Date: 10/12/21

ADDENDUM # 1

St. Cloud HRA

Wilson Apartments - Accessibility Upgrade

NORTH	DATE	09/28/2021
	PROJECT	2107
A2

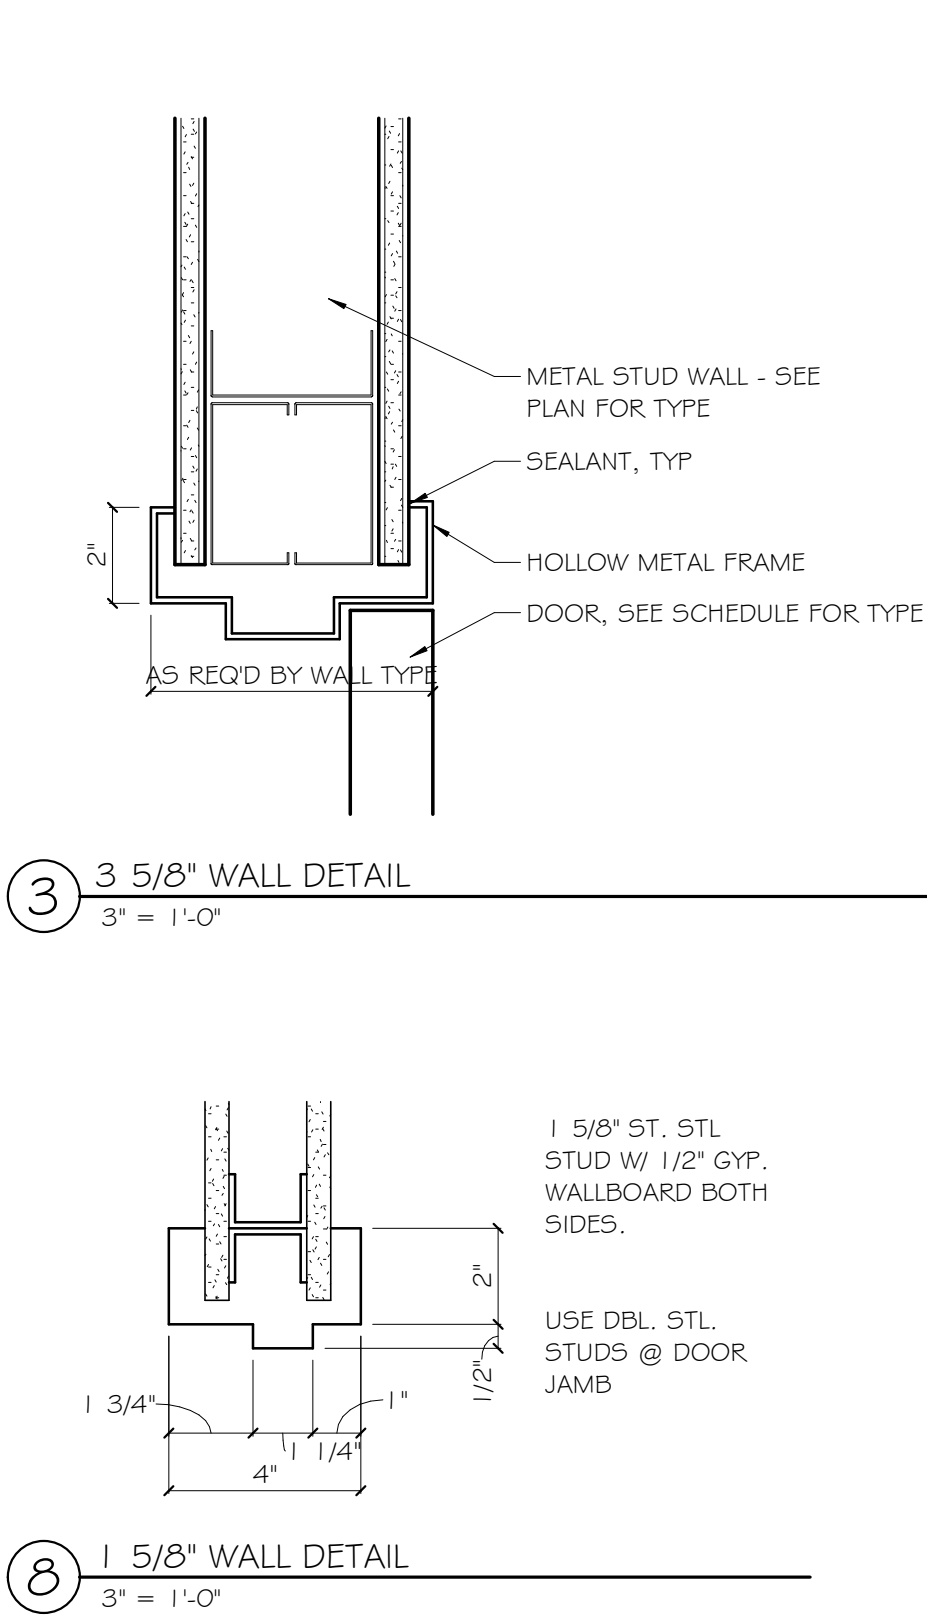
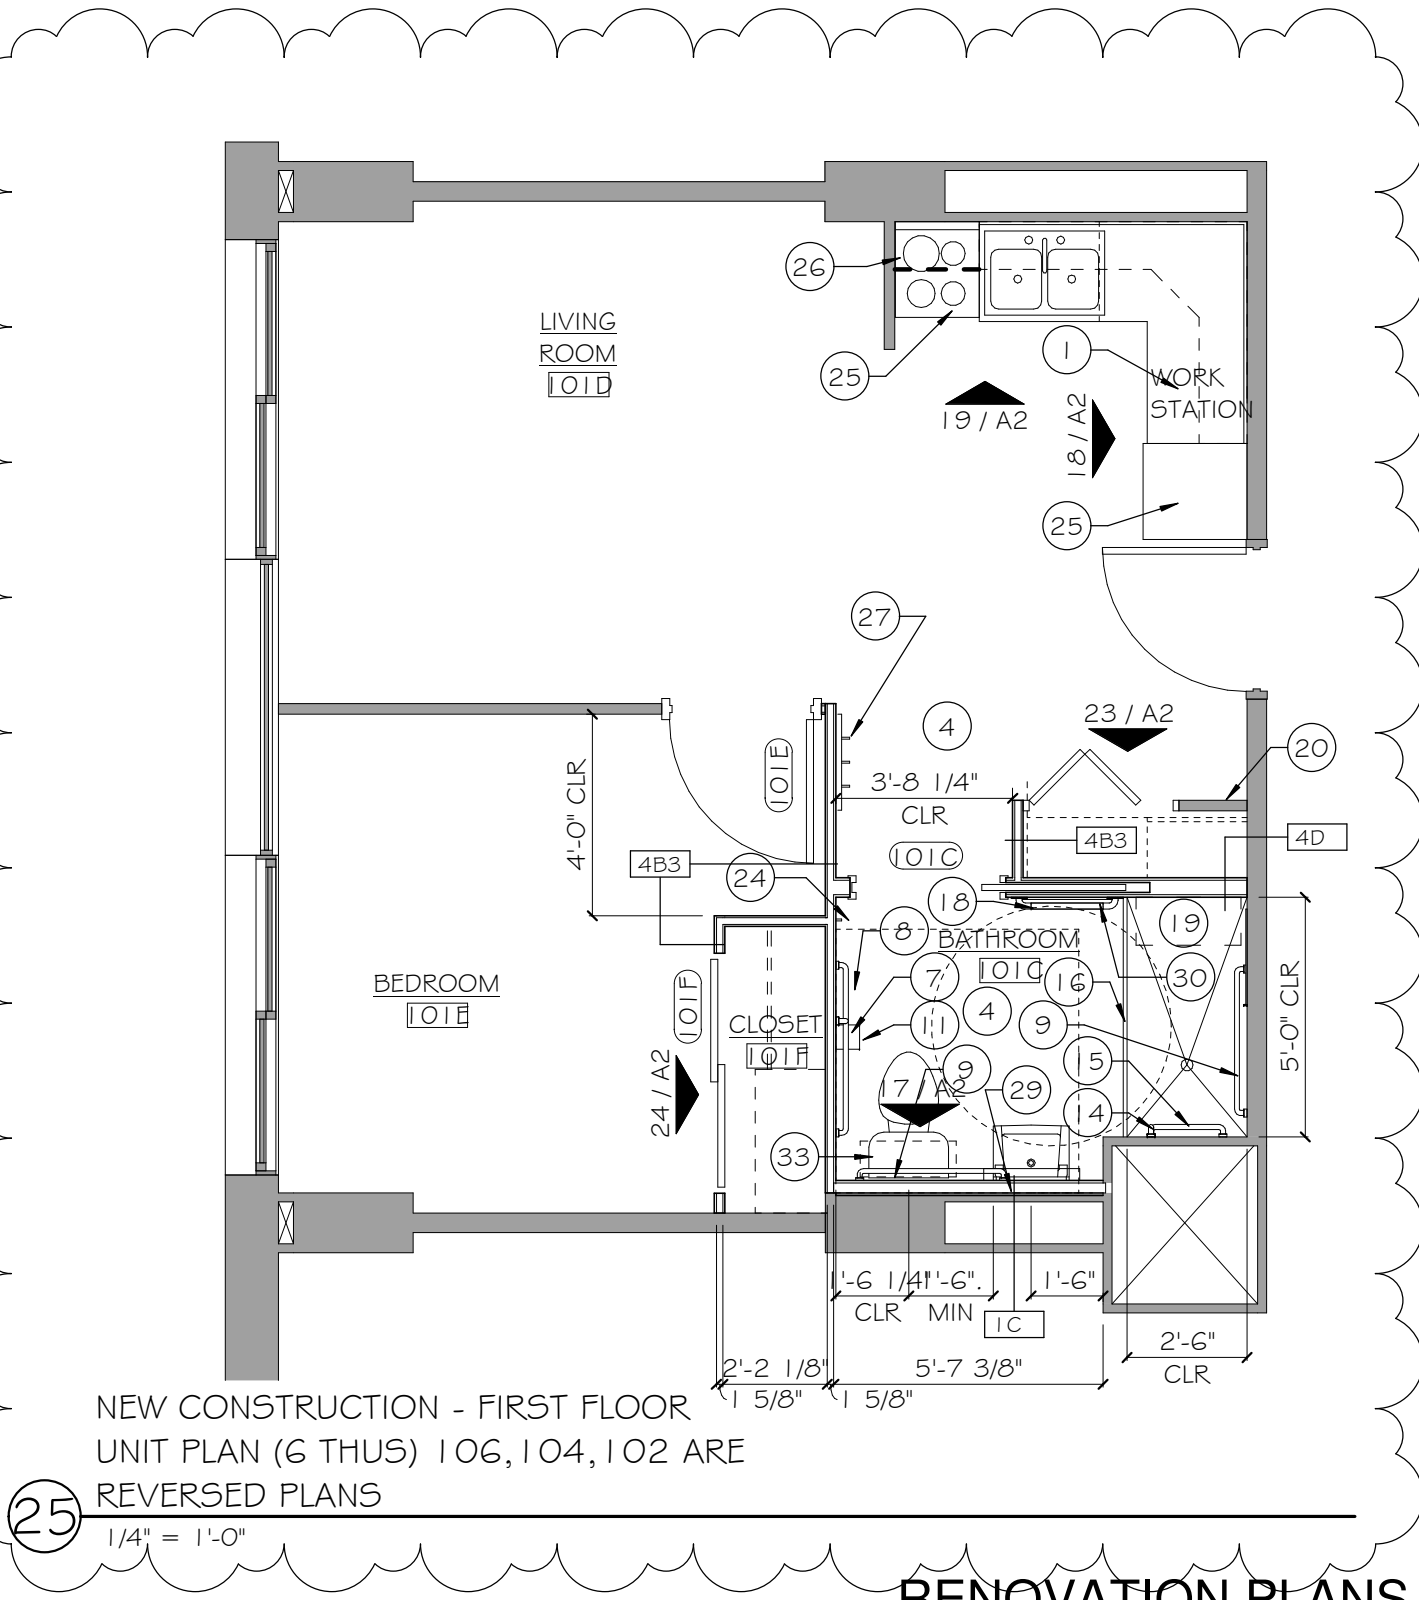
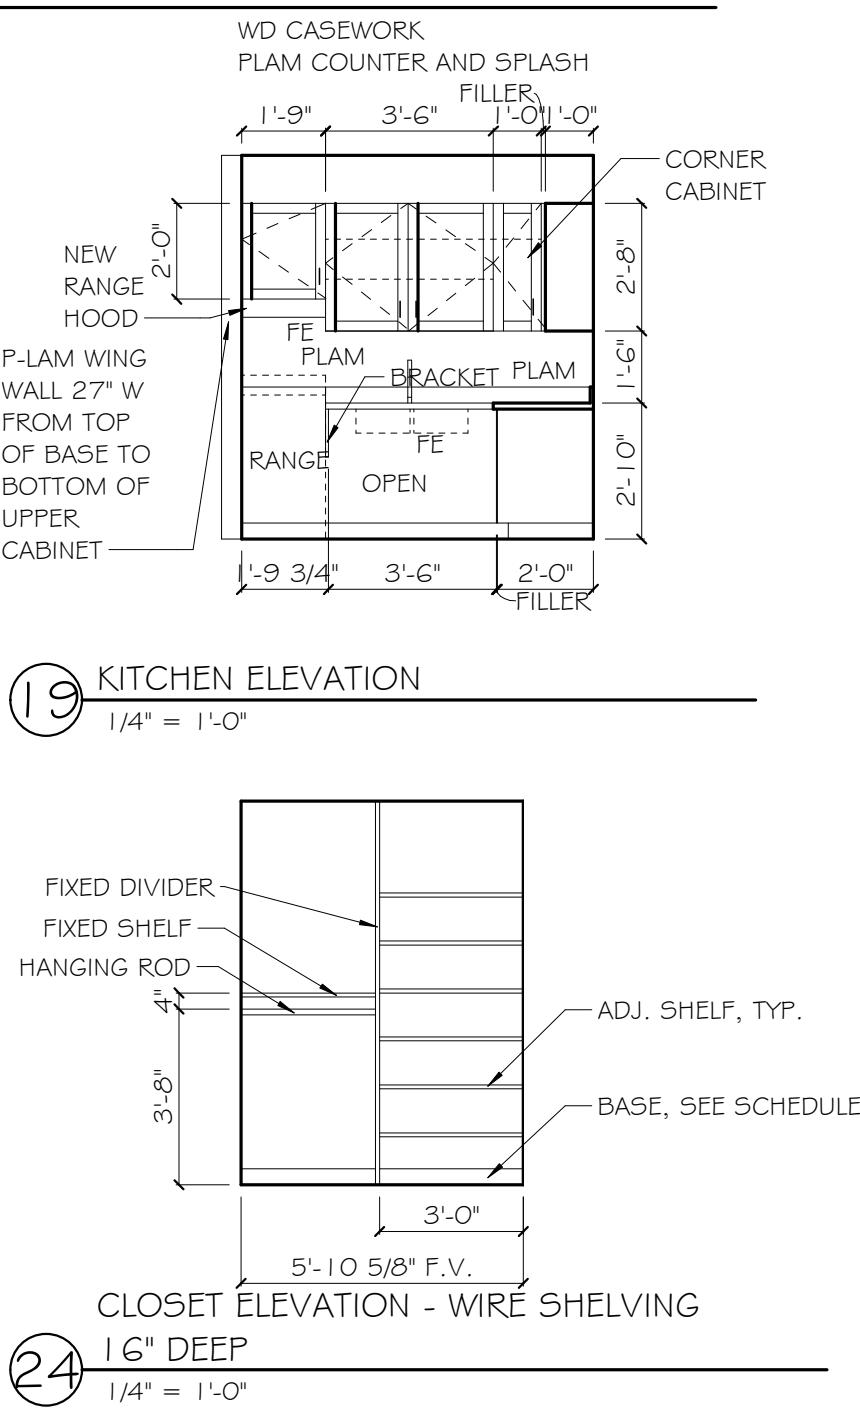
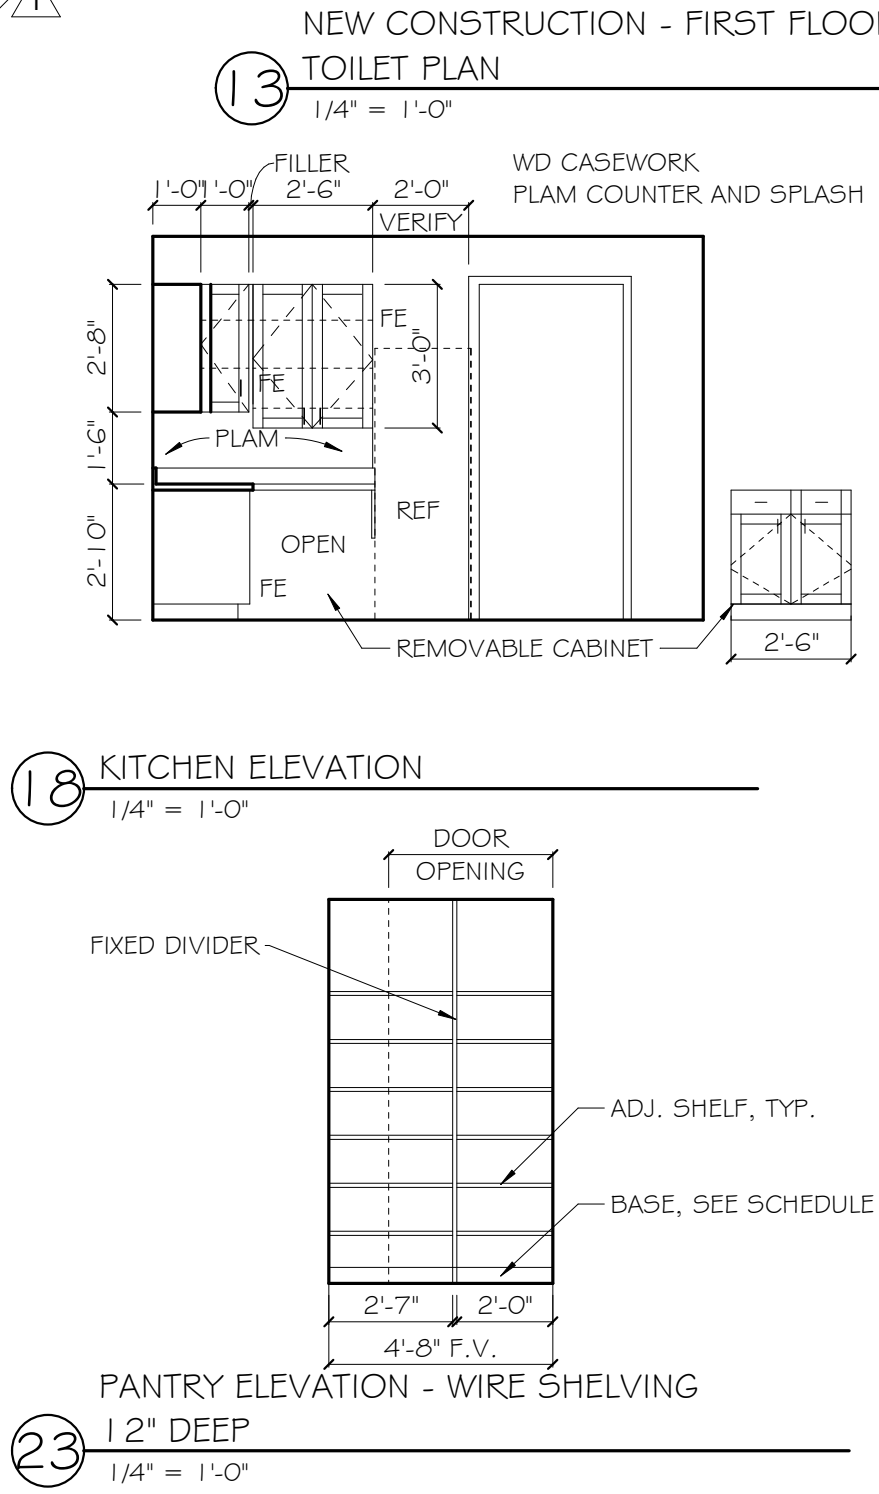
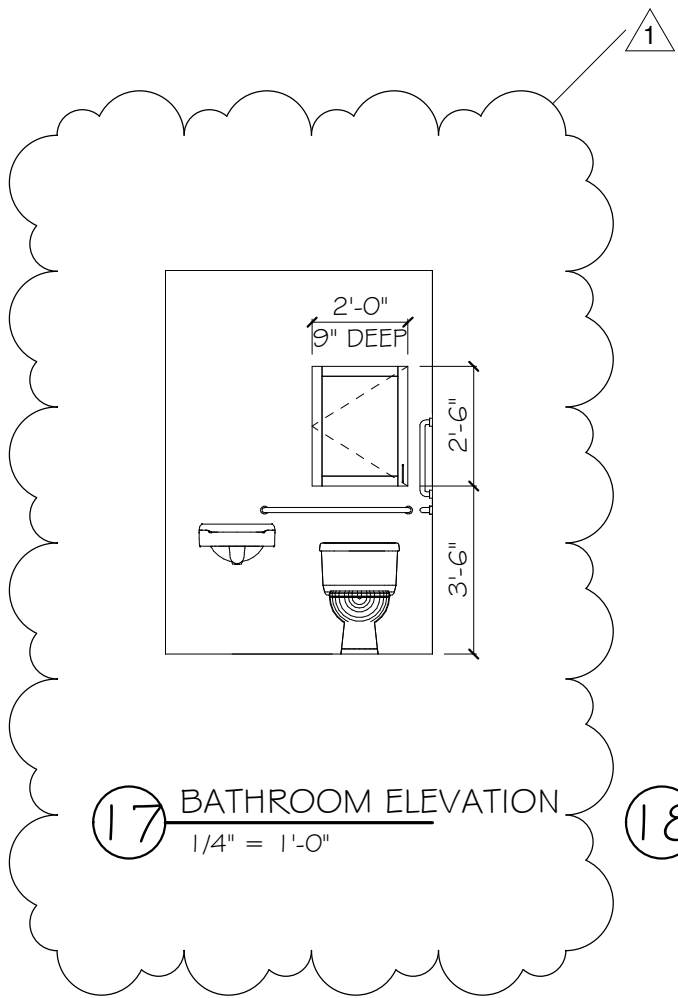
B. Sheet A2.

1. Add shelf unit above the toilets in the apartment units.

- NEW OVER TOILET CABINET
